## ADDENDUM NO. 2

**PROJECT:** Jefferson Avenue Footbridge Rehabilitation STP-5903(803)

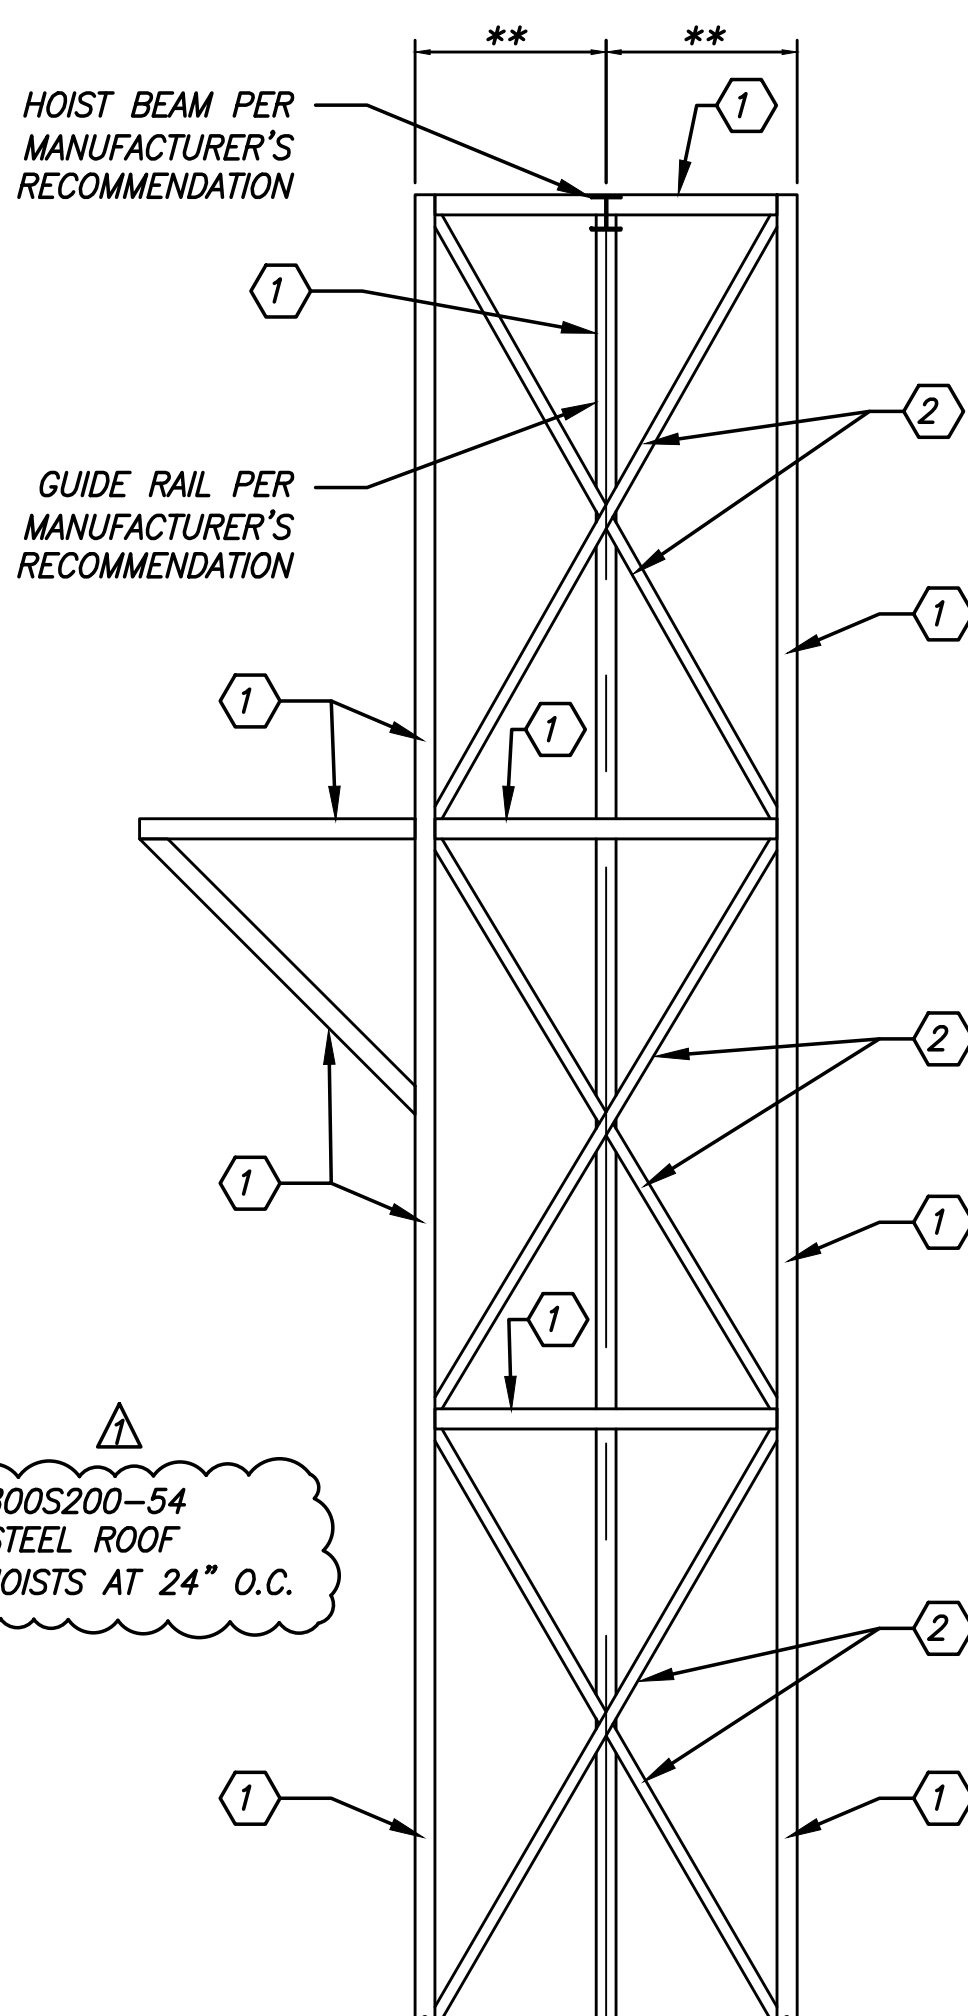
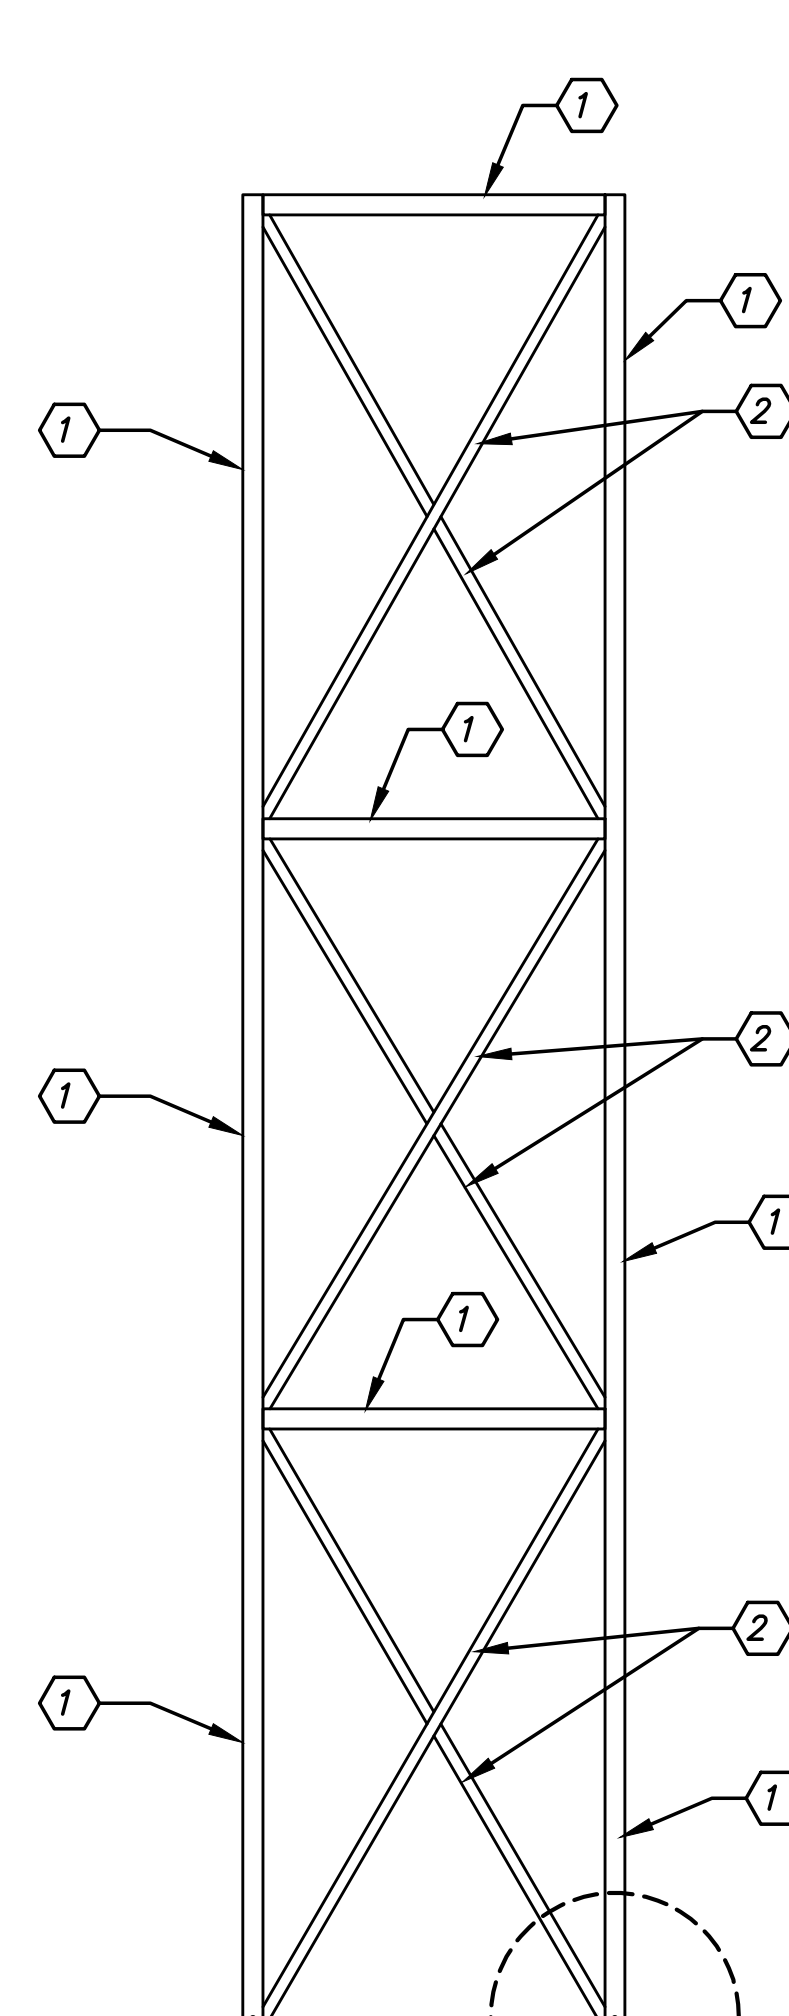
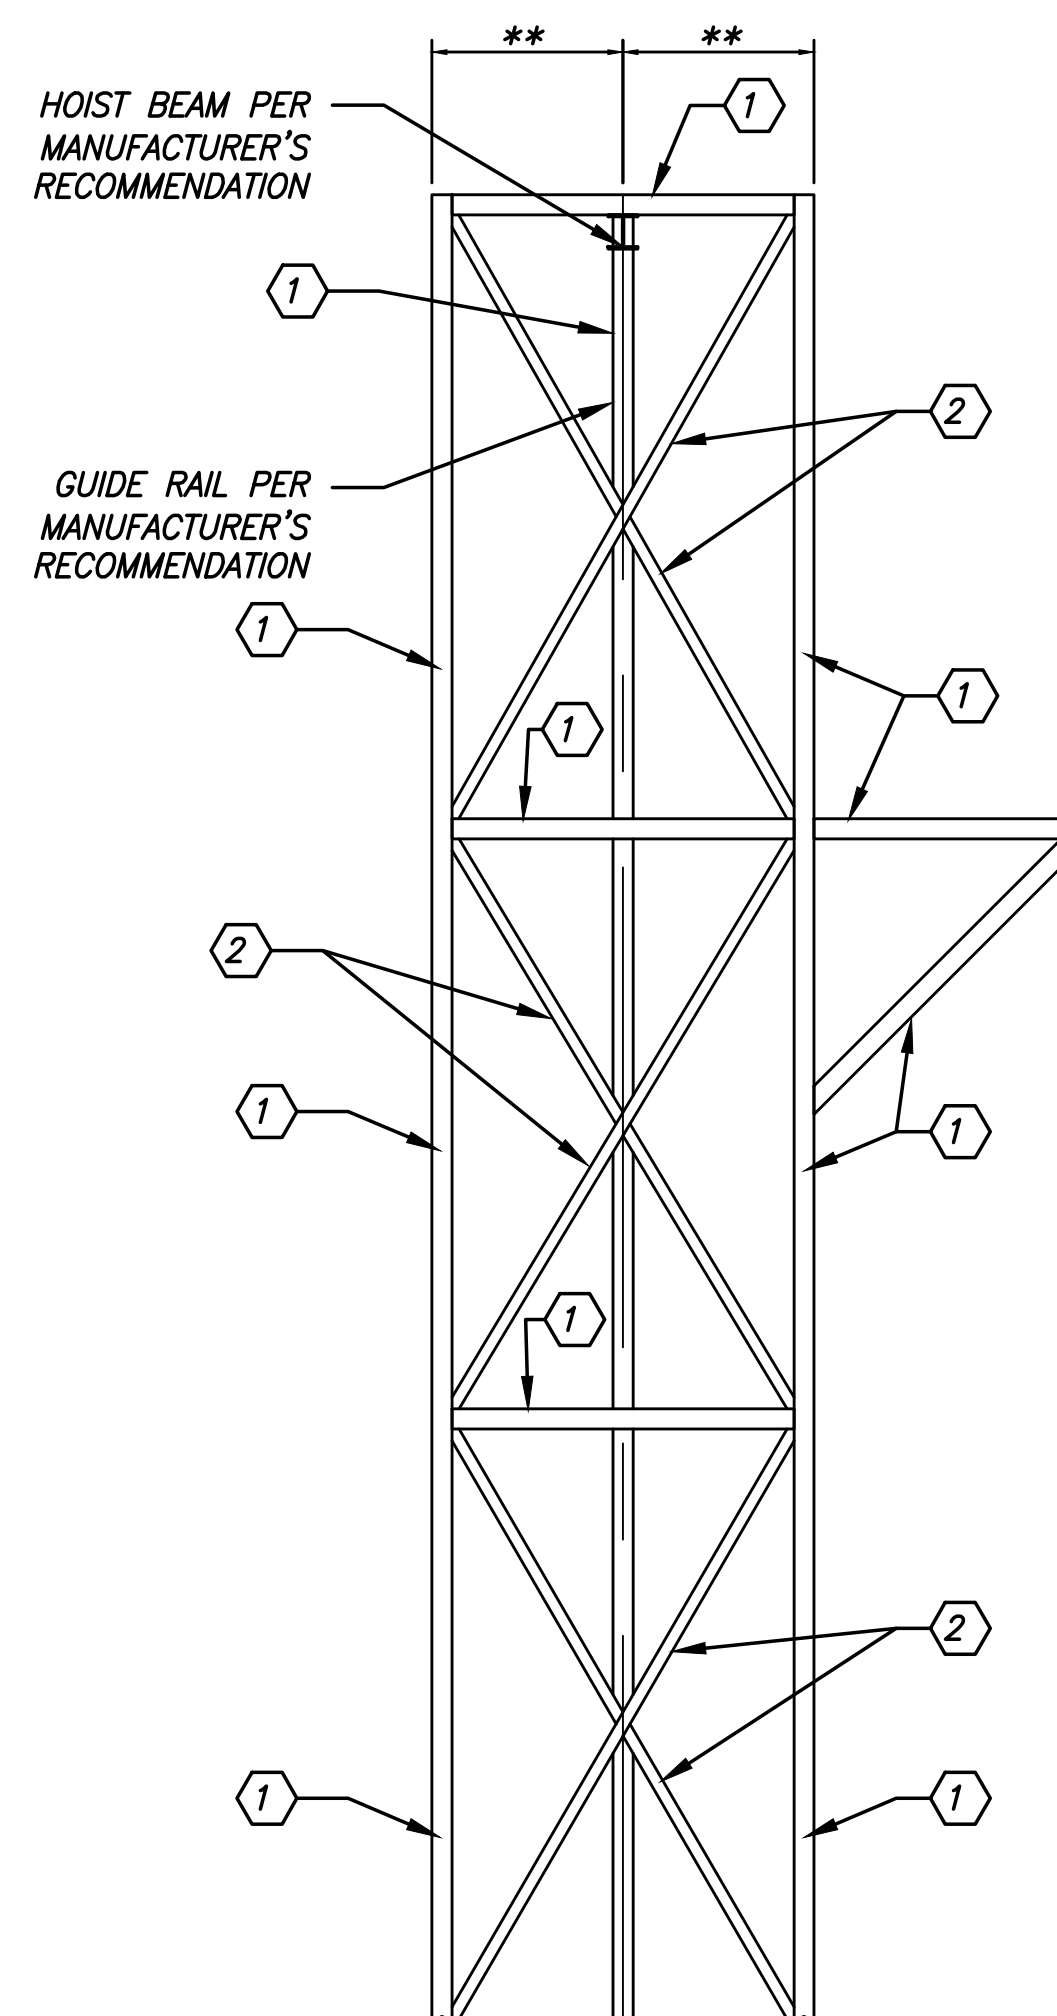
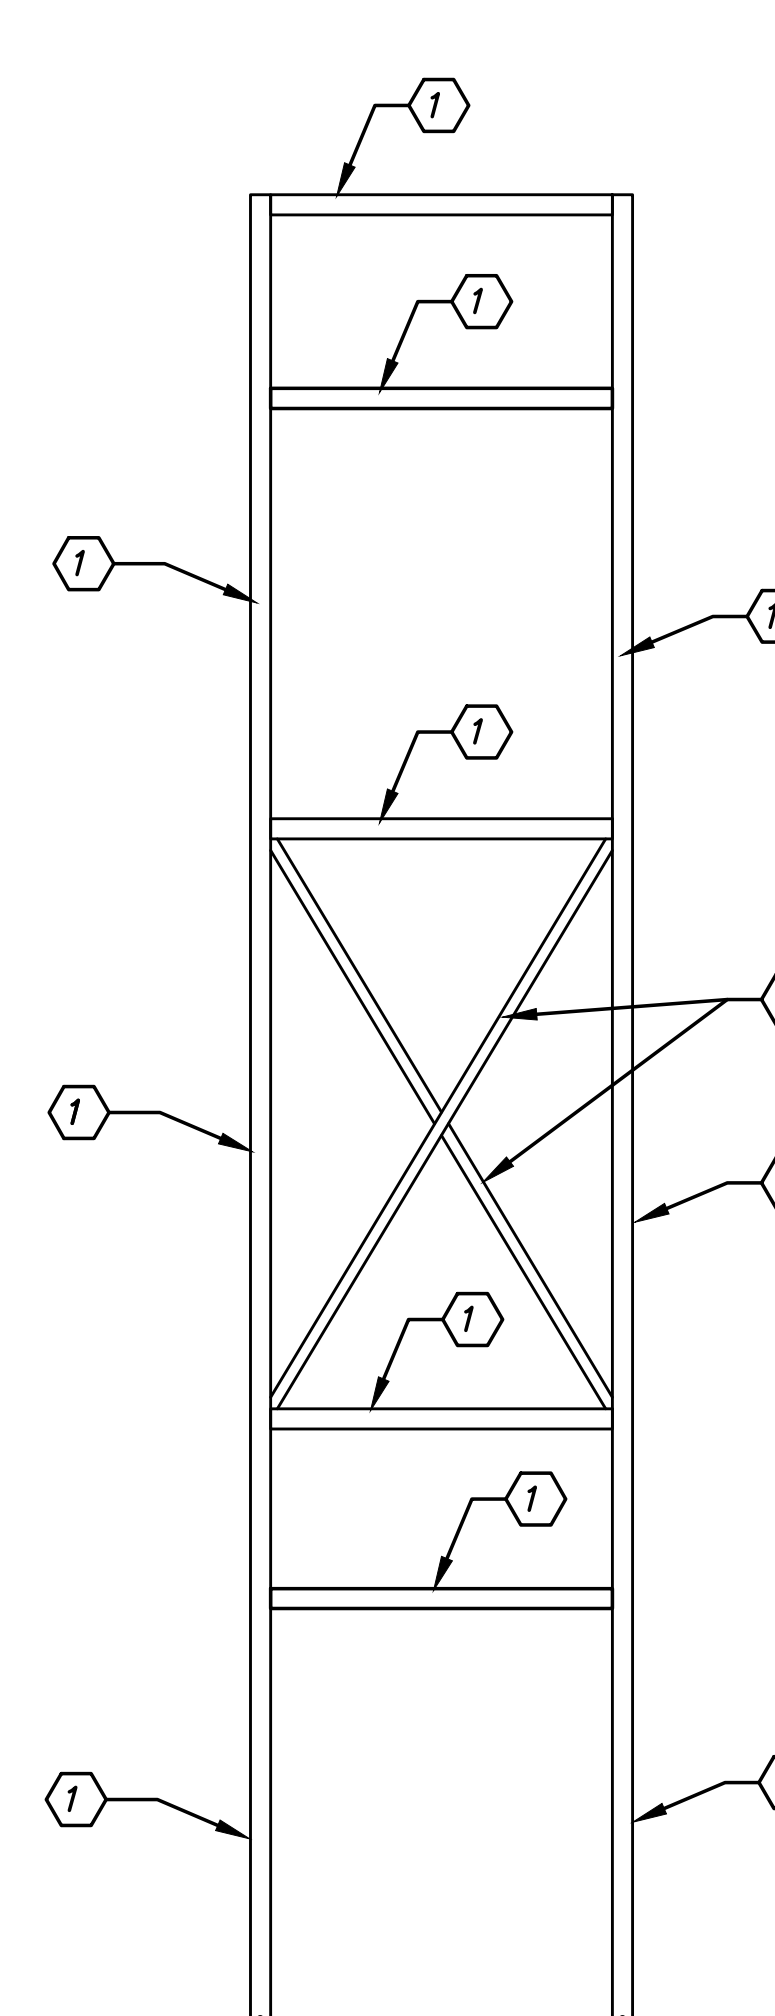
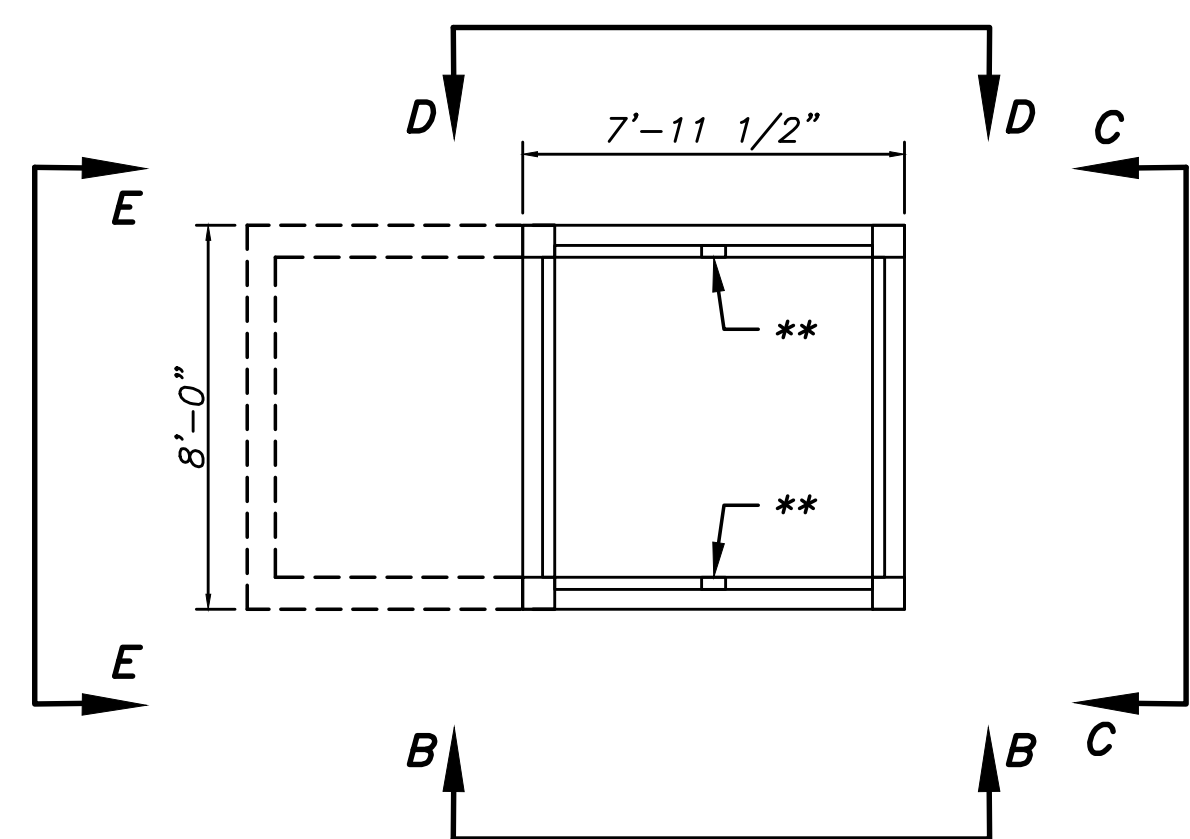
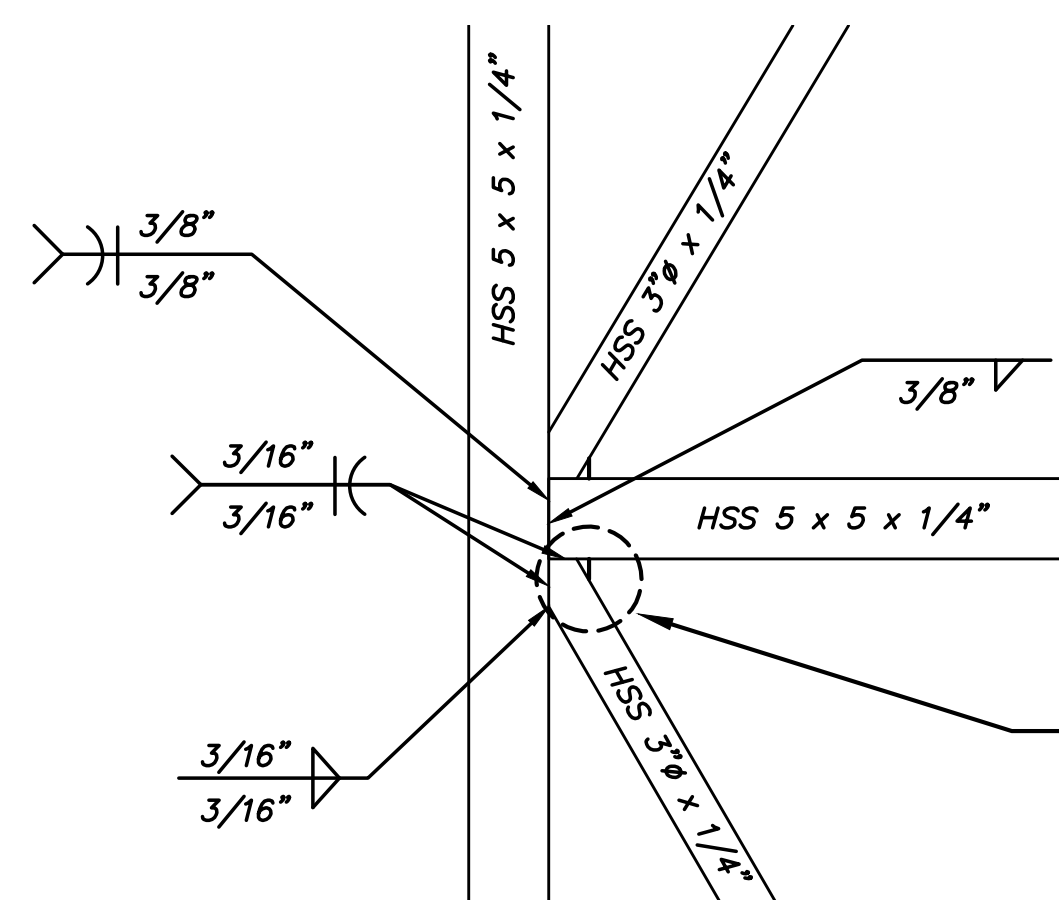
**Question 4:** Regarding Sheet A1.2 refers to the structural drawing for the roof framing members. Can you direct us to these details, member sizes, and materials?

**Answer 4:** Roof framing shall be 800S200-54 steel joists spaced at 24" o.c. Sheet 31 has been revised accordingly and is included with this addendum.
